**Agenda Item 3
Bank Lane Streetscape
Enhancement Concepts**

TO: Chairman Grinnell and members of the Historic Preservation Commission
DATE: December 10, 2024
FROM: Abigail Vollmers, Senior Planner
SUBJECT: **333 N. Green Bay Road – Fencing for a Previously Approved New Home**

**THE CITY OF LAKE FOREST
HISTORIC PRESERVATION COMMISSION APPLICATION FOR A
CERTIFICATE OF APPROPRIATENESS**

Ms. Abigail Vollmers, Senior Planner
The City of Lake Forest
Re: Review of Windows at Northern Trust Bank

3 4' WOOD PRIVACY FENCE
SCALE: 3/8" = 1'-0"

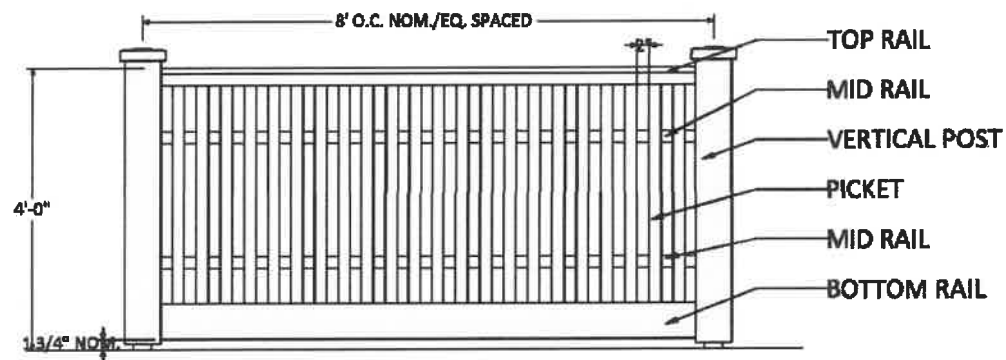
The previously proposed brick piers have been eliminated to address concerns about the contrasting colors. After further review of the Commission comments, the petitioners propose to maintain the vertical picket spacing as previously presented in Option 2 in order to contain their pets. The opacity of the fence now proposed is 64% open. The fence will remain at the previously proposed 4' height.

This standard is mostly met. The 4 feet high fence allows more of the wooded landscaping within the conservancy easement to be seen. As drawn, Option 2 will provide a 64% openness. While this does not meet the 80% openness requirement for the lot subdivision, the additional two feet of unobstructed view to the vegetation honors the intent to preserve the wooded character of the Green Bay Road streetscape, and the newly proposed landscaping in front of the fence will minimize the view of the pickets.

Grant a Certificate of Appropriateness approving the fencing plan as reflected in Option 2 at 333 N. Green Bay Road subject to the following conditions of approval.

265 Deerpath, Lake Forest Window Key

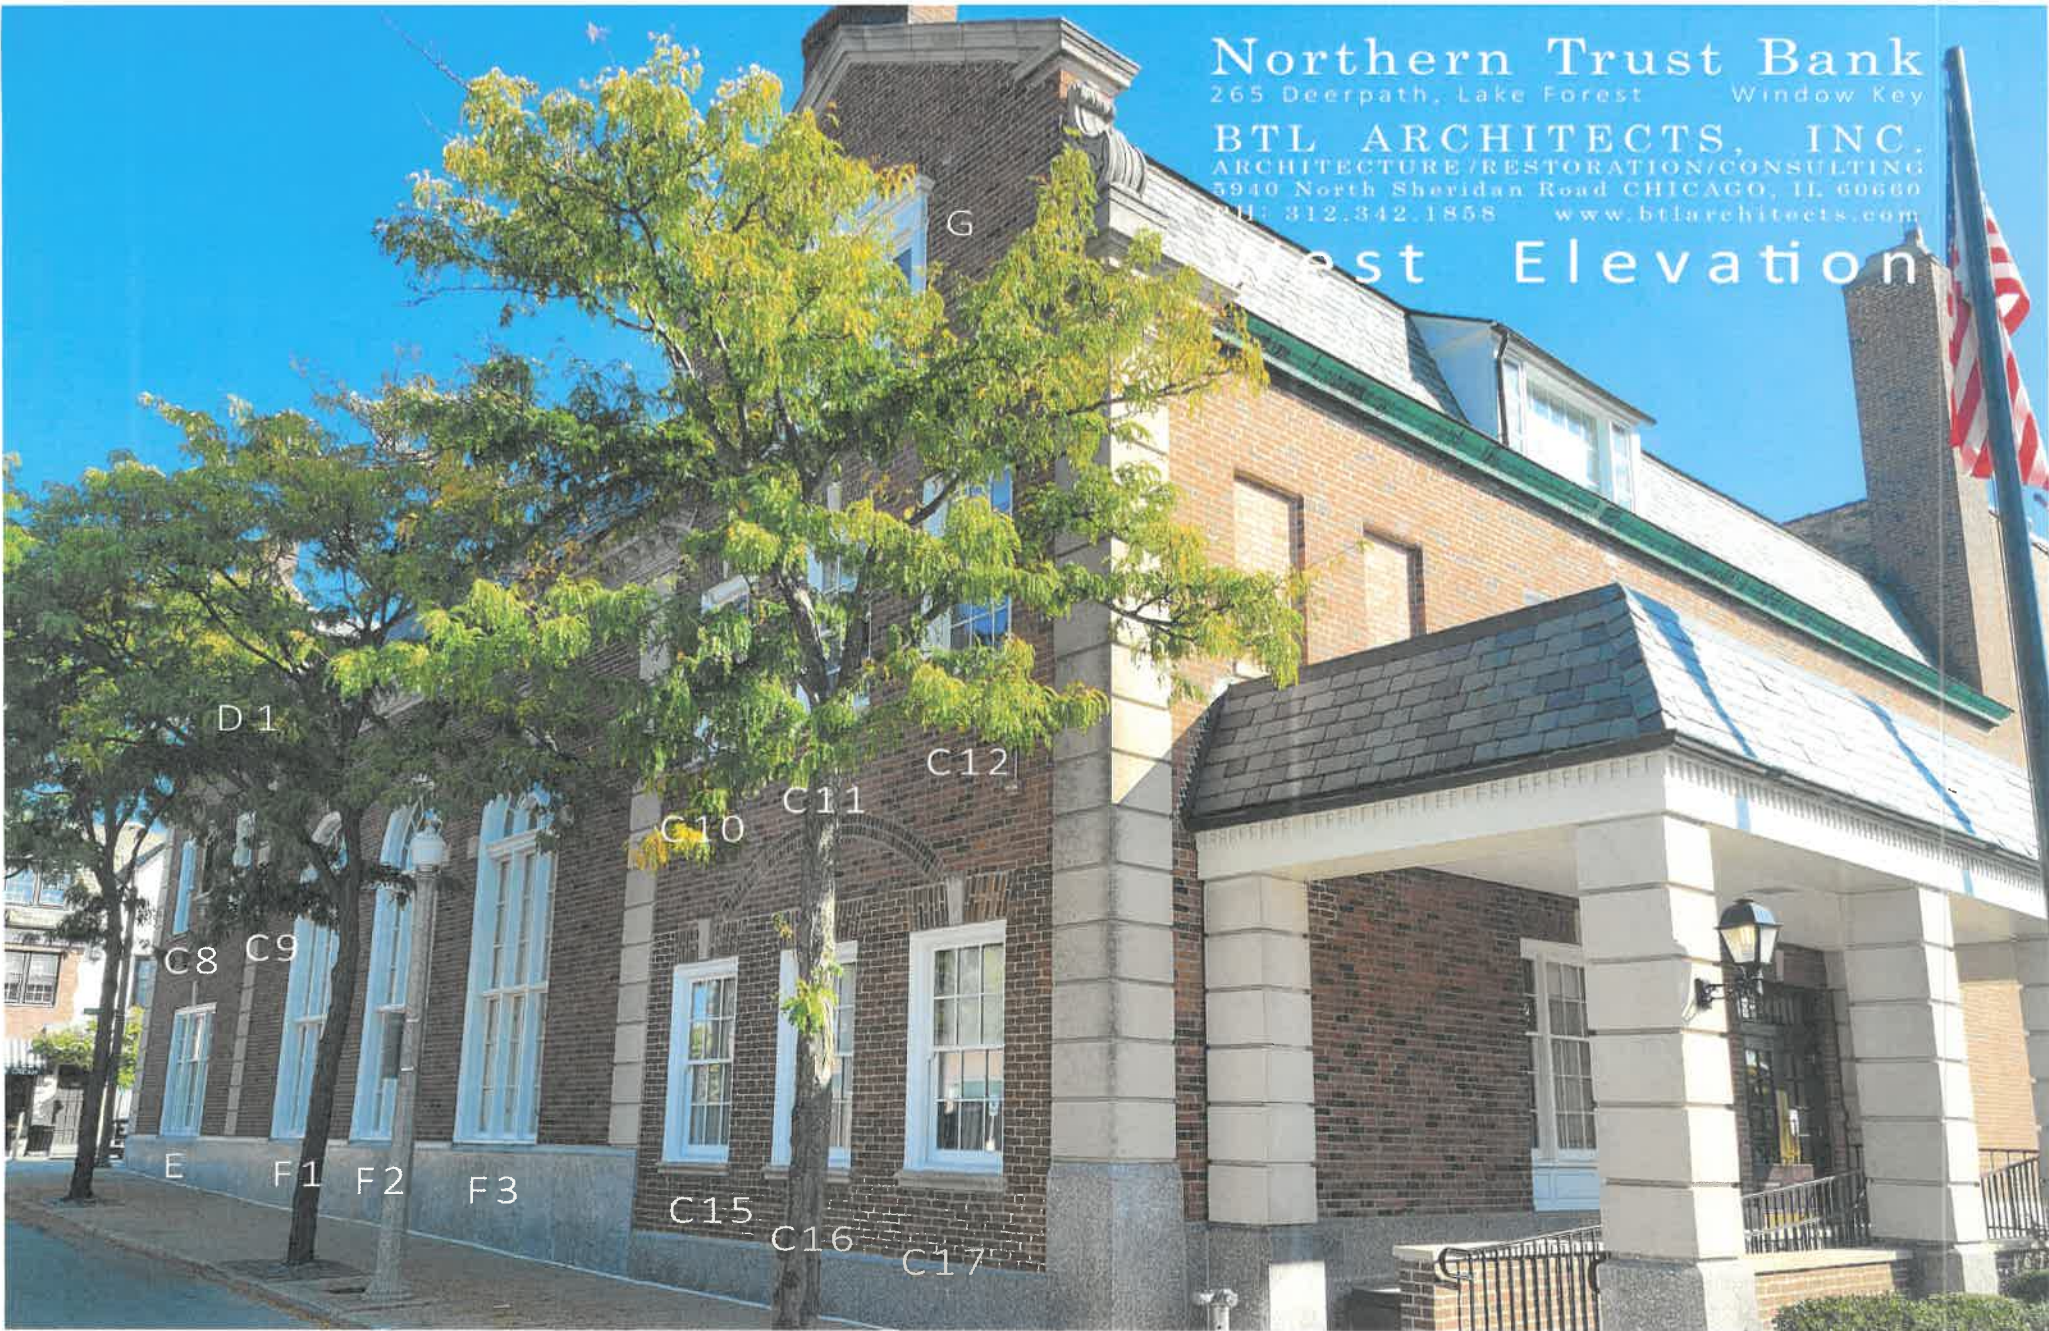
Previously replaced (non-historic) – These windows have no historic value and their replacement does not pose a preservation concern. The proposed aluminum clad wood windows are intended to match the muntins and trim of the existing non-original windows in an effort to maintain the look of the existing windows. The change in material will result in a different textural appearance. The use of wood brick mold trim would provide a more historically accurate material between the clad windows and the surrounding brick as proposed by the petitioners for Window Type G in which the decorative surround is proposed to be retained.

Given the dominant role Window Type F plays in the building's character, preserving the historic profiles and details of these windows is important to preserving the historic integrity of the building. Staff recommends further investigation into restoration feasibility and a plan for either restoration or replication be presented to the Commission.

1. A detailed restoration plan or documentation demonstrating why restoration is not possible.
2. If restoration is not feasible provide detailed plans for replicating the original windows and trim in kind to match the existing profiles and details with attention paid to adding energy efficiency with either storm windows or double pane glass. The wood material should match to the greatest extent possible.
